Staff Report

To: BOZAR
From: Jessie Earley, Senior Planner
Meeting Date: BOZAR, January 27, 2026
RE: 45 Augusta Drive, Final Review

PROJECT TITLE: Augusta Park Partners LLC (45 Augusta Drive)

SUMMARY: Consideration of the application of **Augusta Park Partners LLC** to site a single-family residence and a cold accessory building to be located at 45 Augusta Drive, Lot T5, Slate River Subdivision in the R1F zone.

Proposed Site plan

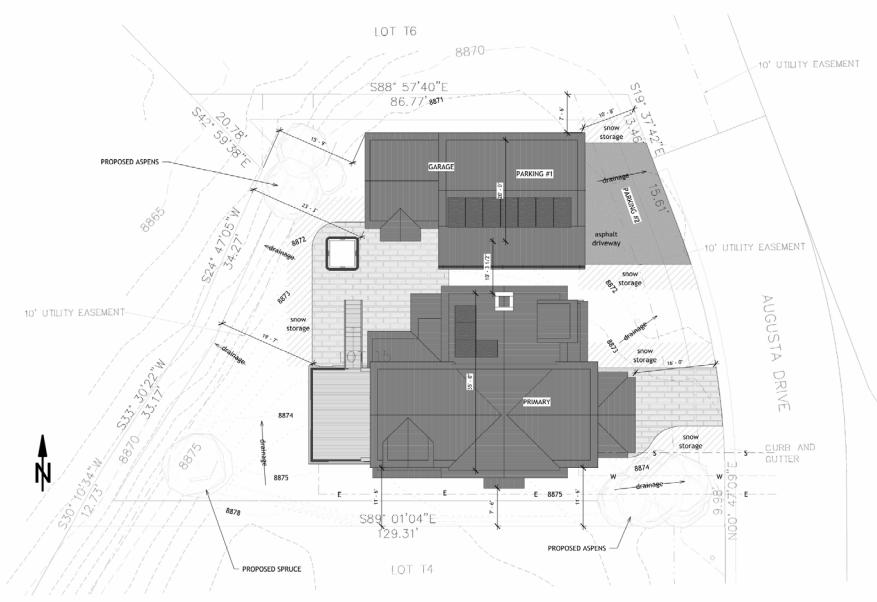
GL	Staff Analysis	DRC Recommendation
Topography	<p>On the southwest corner of the lot the grade is noted as 8870'. This transitions to 8876' on the eastern portion of the lot.</p> <p>Over the course of the primary building footprint, the grade is 8875'9", which is the elevation used for measuring FAR.</p> <p>For the purposes of measuring FAR for the accessory building, the grade is 8872'.</p>	
2.8 Drainage	Drainage information has been provided. Drainage arrows for the site have been shown.	<p>12/8 DRC: Add information to plans.</p> <p>1/12 DRC: Add information to the site plan. Information added.</p>
Easements	There is a 10' utility easement for the east and west side of the lot. This has been called out on the site plan.	Add information to the site plan
2.16 Substantial landscaping	The plan is fairly minimal. Provision of

a final landscape plan will be required for review and approval if revisions are proposed after permitting prior to a CO.	
2.19 New trees	There are a cluster of aspens proposed on the southeast corner, cluster of aspen trees on the northwest corner and a proposed spruce on the southwest corner, which appears to meet the intents of GL 2.19 a as it requires two trees and 4.28.	12/8 DRC: Two trees must be added to satisfy the requirements of this GL. The site plan was updated.

2.16 a./ 2.20 Native plantings	Ground cover is not noted. Native materials are encouraged by the GL.	Add information to plans.
2.16 e Pervious materials 2.28 e &f Parking substrate	<p>Walkway, and patio (420 sf, 1046 sf) are not called out but appear to be pavers.</p> <p>There is an area for the driveway to the accessory that is asphalt (496 sf). Board members can discuss whether these areas are consistent with other proposals.</p> <p>Parking spaces are now called out on the plans.</p> <p>Comparison data: 65 Pyramid Ave: 1968.15 sf (pavers/asphalt) 75 Pyramid Ave: 2615 sf (pavers/concrete/gravel) 31 Augusta Park Drive: 1883.97 sf (pavers)</p>	Support

2.7 Snow Storage	Snow storage has been provided onsite and it meets the 33% requirement of the areas to be plowed.
